Date: August 28, 2015
Project No.: 535-1-3
Prepared For: Mr. Ed Abelite
CANYON CREEK PLAZA, LP
5601 Silver Creek Valley Road
San Jose, California 95136
Re: Geotechnical and Geologic Hazards Report Update
Canyon Creek Plaza
5601 – 5667 Silver Creek Valley Road
San Jose, California

This letter is to update our previous geologic and geotechnical reports. We have been provided with a set of plans titled “Planned Development Plan “Exhibit C”, Canyon Creek Plaza, New Retail/Commercial Building to Existing Shopping Center, 5601-5667 Silver Creek Valley Road” prepared by LPMD Architects, and dated June 3, 2015.

Geology Map		Project Number
	Canyon Creek Plaza 5601 Silver Creek Valley Road San Jose, CA		535-1-2
			Figure Number
		Figure 2	Date
			September 2014
			Drawn By
			RRN

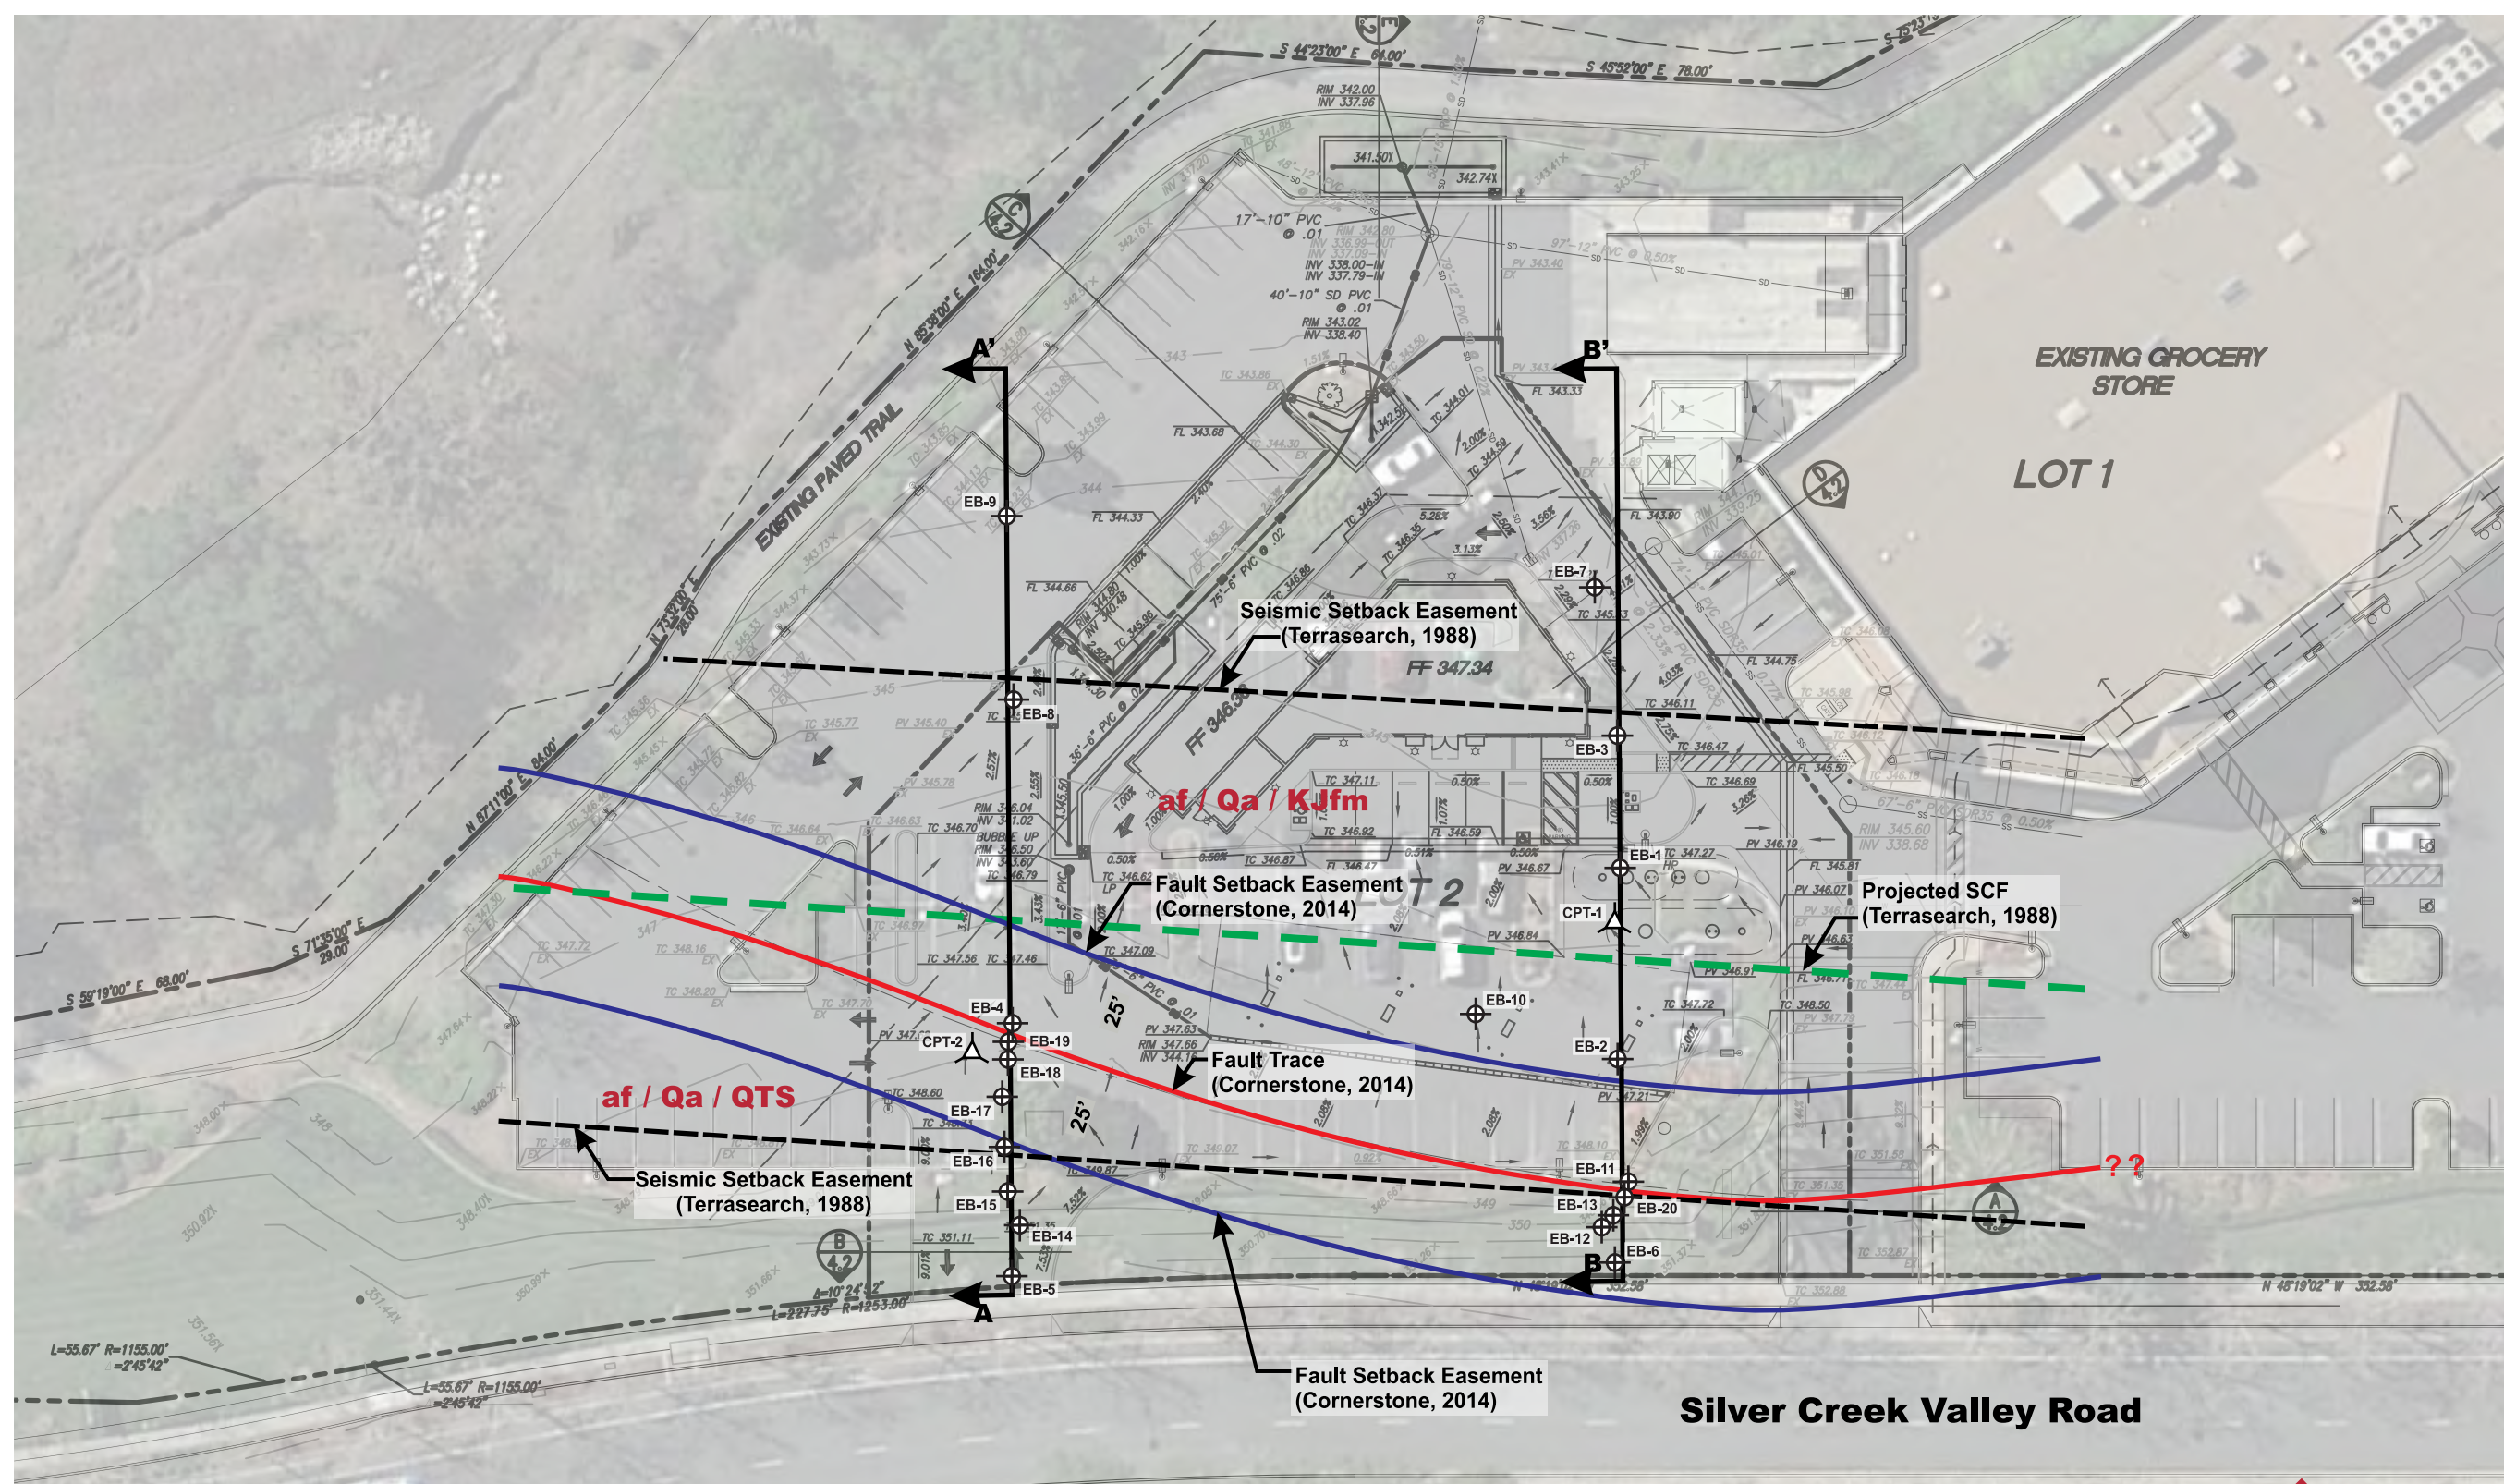
DPW Comment #16: Although the location of a fault is delineated on Figure 2 of the CEG study, the subsurface conditions are not sufficiently characterized to allow an adequate surface fault rupture hazard evaluation to be made. Other data necessary to evaluate the fault rupture and surface deformation hazard potential include characterizing the nature and geometry of the soils overlying the fault, the amount of anticipated fault displacement/slip rate, type of fault movement, orientation of the fault plane, width of fault zone, and other factors (Treiman, 2009). The subsurface characterization of the fault, bedrock and overlying soils should be presented in greater detail and depicted on cross sections. The width and dip of the fault plane should be presented. Due to the presence of 15 to 20 feet of soil overlying the fault, the anticipated fault rupture propagation path to the surface through the overlying soils should be evaluated and the surface location of the fault rupture and the aerial extent of potential surface deformation determined (Bray et. al., 1994, Treiman, 2009). The recommended setback appears to be based on fault rupture propagation of a vertical fault plane less than one foot wide. Based on empirical and laboratory studies of fault rupture propagation through soil (Bray et. al., 1994), if the CEG fault is characterized by reverse movement and the fault plane is east dipping, the estimated fault rupture path may result in surface rupture beneath structure, and the recommended 25 foot setback may be inadequate. The 25 foot setback may also be inadequate if the faulting is present within a zone of shears rather than a discrete single shear plane. The recommended fault setback should be reevaluated based on the above data and discussion.

CEG Response to DWP Comment #10: The recorded SSE and our revised BEZ were depicted on our Figure 1 of our previous report and on the attached figure. At the northwest property line, our BEZ coincides with the northeast limit of the SSE, and as our BEZ trends through the site it curves with a broad arc in a more southerly direction so that by its intersection with Cross Section A-A', it is located completely within the SSE. Curves or arcs in the surface trace are documented in the mapping of Terratech at locations further to the southeast. Refer to the attached revised site map.
